Responses to the comments of RC1:

Responses to the comments of RC2:

Jin et al. present a sensitivity analysis of improving runoff simulation using CLM5 for loess plateau watershed. They evaluate the parameter parameters and significantly improve the simulation performance. I feel this paper is well written with scientific insights. However, I have some serious concerns and suggestions and hope the authors can clarify/answer.

Figure S1. The geographic distribution of the soil depth for the WRB.

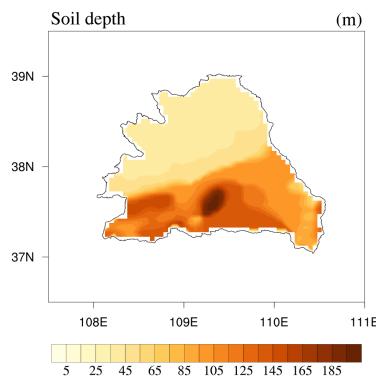
Therefore, what the authors are investigating here is not the addition of variable soil thickness but the impact of vertical resolution with variable soil thickness. They need to make this crystal clear in Section 5.1. Also, are the bottom of the “soil” columns all at the same depth in each of the SLN sensitivity tests? If so, the authors should state that. If not, the authors should note what the bottom depth in each test simulation is.

L24: What is the depth of the 150 soil layers?

Response: We have revised Section 5.1 based on the suggestion from this reviewer. Yes, the bottom of the soil columns is at different depths across the watershed in each of the SLN sensitivity tests except for the default run with the fixed soil depth of 8.03 m (see Section 2.2.2.1 in Lawrence et al. 2018). The spatial distribution of the soil depth is shown in Figure S1, and was also added to the manuscript as Figure 1b.

Response: The geographic distribution of the soil depth in the Wuding River Basin is shown in Figure S1 for our responses to the comments of RC1, and this figure was also added to the manuscript as Figure 1b. The soil depth data were from observations, and were used for the 150 soil layer model simulations.

Figure S2. The ratios of the observed (dark line) and simulated (red line) runoff (default model) to observed precipitation for the WRB over the period of 1956-1969 based on the default options of CLM.

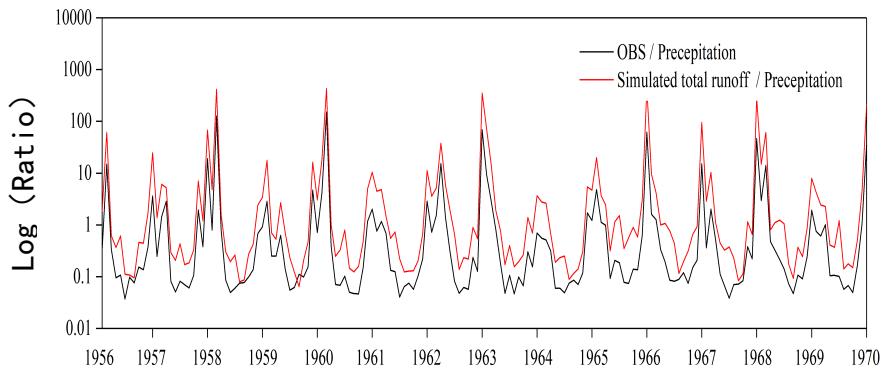
L249: Also shown in Figure 2 and 3, the total water budget or accumulated runoff are way more greater than the observation. I think it will be helpful to plot their ratio against the total precipitation.

Response: We have plotted the ratio of both observed and simulated runoff to observed precipitation and found that the ratio over the summer rainy season is less than 1 (Figure S2). However, the ratio is much larger than 1 during the winter and spring dry seasons. This is because the runoff comes mostly from the groundwater during the dry period when

precipitation was very weak. During this period, the magnitude of runoff is often greater than that of precipitation. Figure S2 shows that the simulated runoff to precipitation ratio is larger than the observed value, resulting from the underestimated evaporation as discussed in Section 6.5.
